Planning Application 18/04521/APP

For: Temporary use of land as a construction compound (Compound B6) incorporating storage area, site offices and car parking.

At: Land South of Bletchley Road, Newton Longville and Newton Road, Bletchley

Submission by Newton Longville Parish Council, 6th February 2019

Figure C.4: Proposed entrance way for B6/Bletchley compound

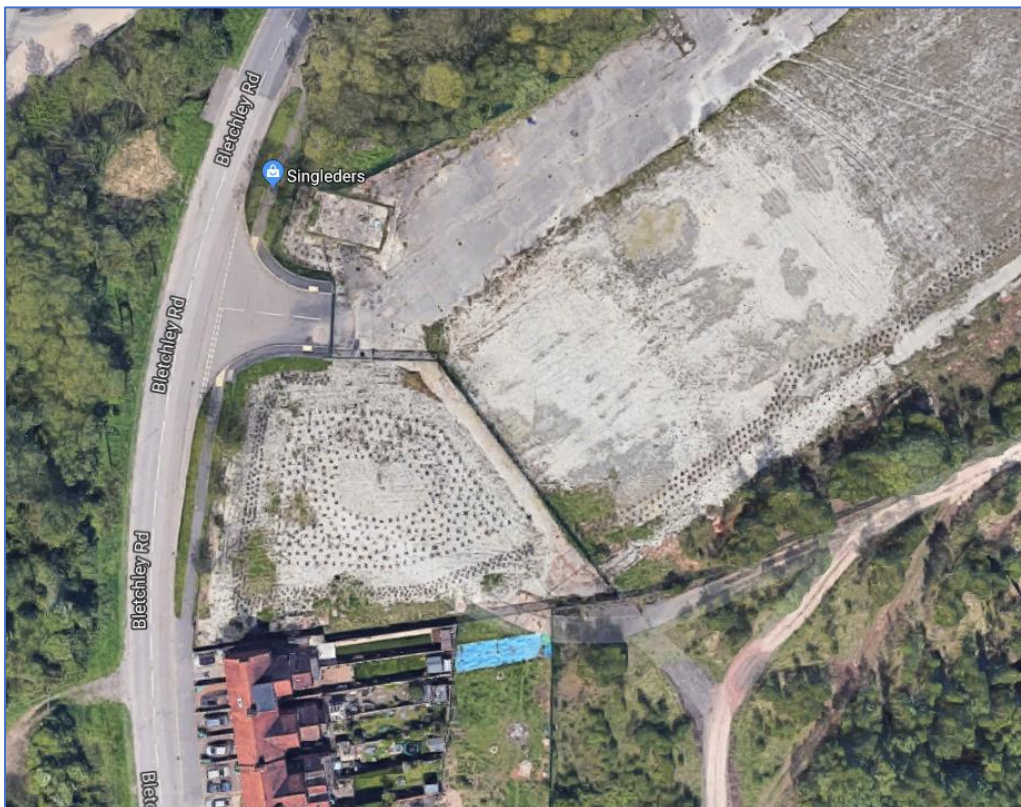
The picture in Figure C.4 on page B-2 (under paragraph B.1.2) shows what is said to be the present entrance to the proposed compound site. However, picture is now considerably out of date as a result of the commencement of work to implement planning application 13/13/02051/APP (*For: Change of use for open storage - erection of four modular buildings for ancillary office use, ground re-contouring, boundary treatment and landscape. At: Land at Bletchley Road, Newton Longville.*)

As can be seen from the more recent satellite image below, there is now planting with trees to create a sound barrier to protect the houses immediately to the south of the entrance. This protection should not be removed. No rationale has been put forward for re-locating the compound entrance closer to residential properties and through the landscaped bund.

Extract from Construction Traffic Management Plan – Figure C.3

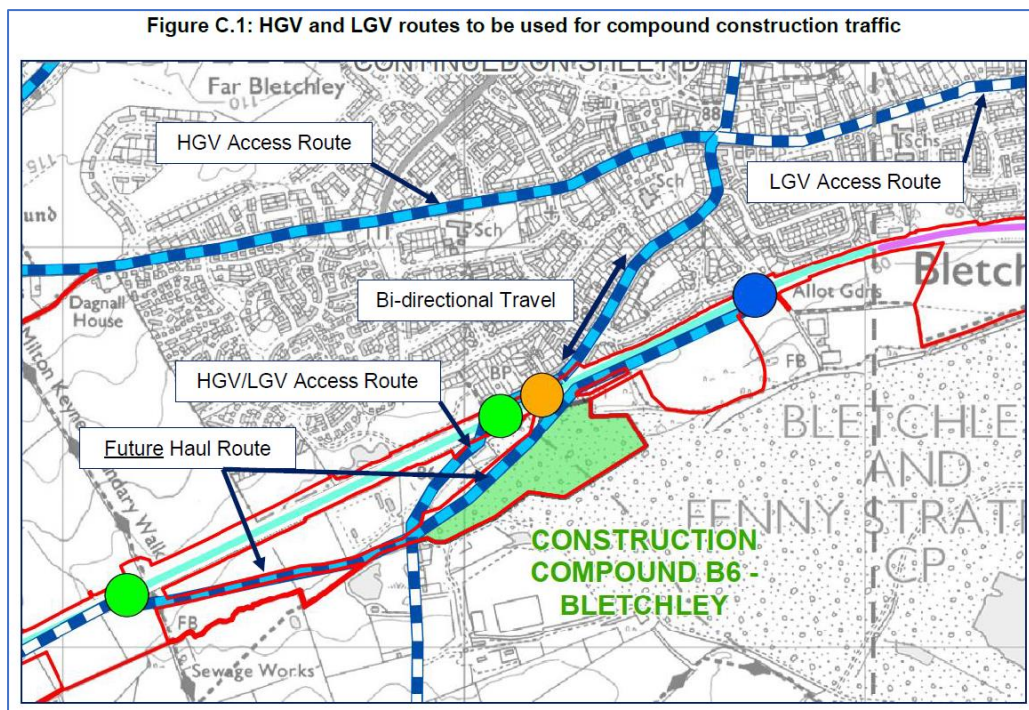
Figure C.3 in the CTMP (below) also shows a more current image that the photo in C.4.

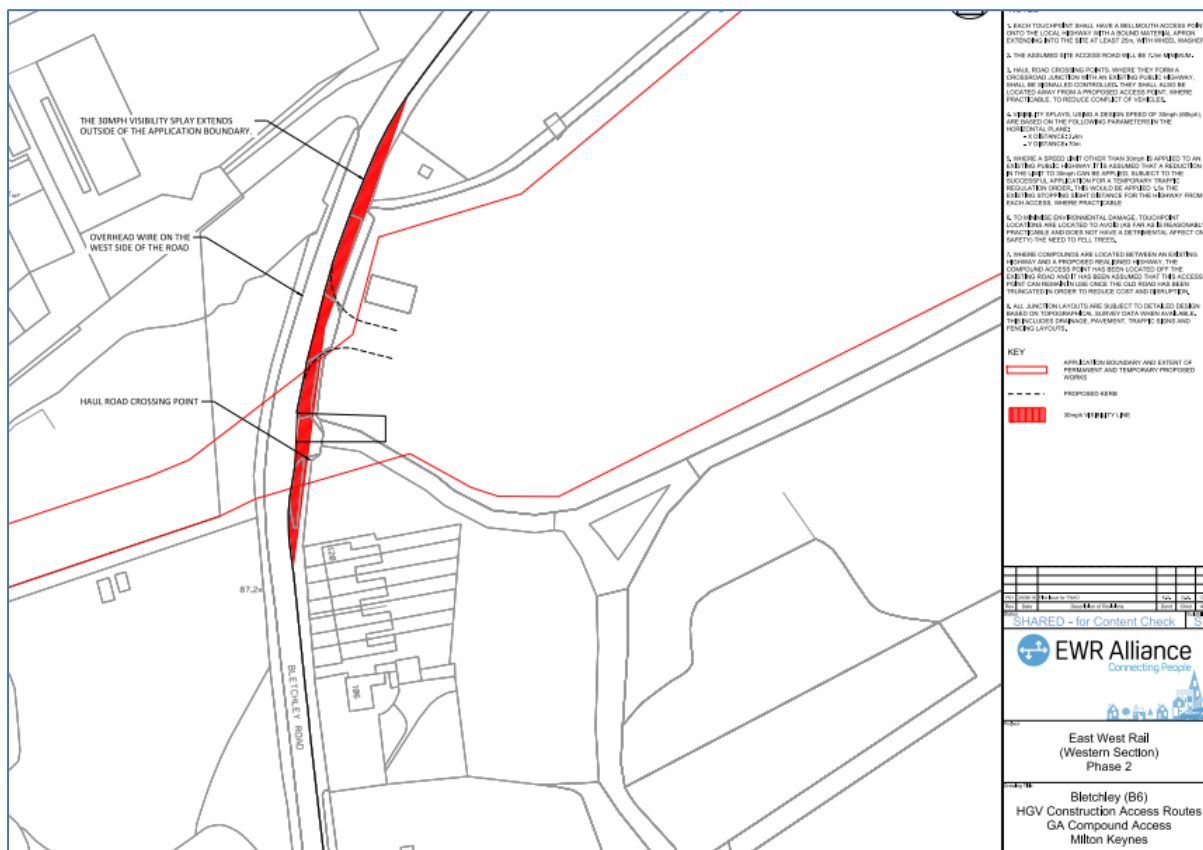
There is residential property on both sides of the proposed compound, there should be sufficient protection to residential properties through sound barriers or other appropriate measures. The suggestion the compound is only close to and may affect only two properties fails to take account of the layout of the compound as a whole. Before the application is determined a noise survey ought to be undertaken to establish baseline noise and specify noise levels to be obtained which should then be secured by conditions. The condition proposed by AVDC Environmental Health is endorsed, but
